URGENT PRODUCT CORRECTION NOTIFICATION

Potential for Unsuppressed Results using VITROS® 5600 Integrated Systems

Ref. CL2018-174ea Page 1 of 3

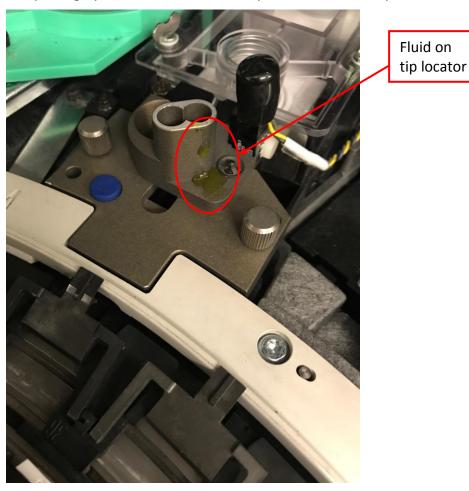
2. How can I determine if sample fluid is present on the VITROS 5600 Tip Locator?

The photograph below shows an example of fluid on the tip locator:

- If you observe unexpected MicroSlide assay results for a sample associated with TE1-504 and/or TE1-594 condition codes, please do the following:
 - Inspect the tip locator to determine if sample fluid is present. Refer to example shown on page three.
 - o If fluid is NOT observed, repeat all MicroSlide assays for the affected sample.
 - o If sample fluid is observed on the tip locator or repeated results do not agree (i.e., incorrect results), contact your local Ortho representative or our Ortho Care™ Technical Solutions Centre for further assistance.
- Complete the Confirmation of Receipt form no later than August 24, 2018.
- Post this notification by each VITROS 5600 System in your facility or with the user documentation.
